INSTALLATION INSTRUCTIONS FOR SOLENOID REPLACEMENT KIT - WD21X10060 and MOTOR REPLACEMENT KITS

For Dishwasher Models with Electronic Drain Feedback Switch

SOLENOID KIT WD21X10060

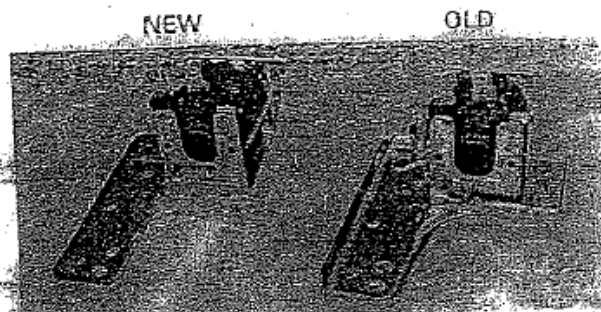
The design of the motor drain solenoid has changed. The new design is a one-piece construction, but compatible with older two-piece bolted assemblies.

On models with Electronic Drain Feedback Switch (EDFS), a special adapter bracket must be installed. See model list on back side of this sheet to identify models with EDFS.

To replace a solenoid on models with an Electronic Drain Feedback Switch (EDFS):
The new adapter bracket must be installed.
This bracket is included with the Solenoid Replacement Kit.

- Attach the adapter bracket to the new solenoid with the 2 screws provided in the kit.
- Secure the solenoid to the pump housing with original screws.
- Attach EDFS to the adapter bracket with original screw or screw provided.

New bracket
attach with
2 self-tapping
screws
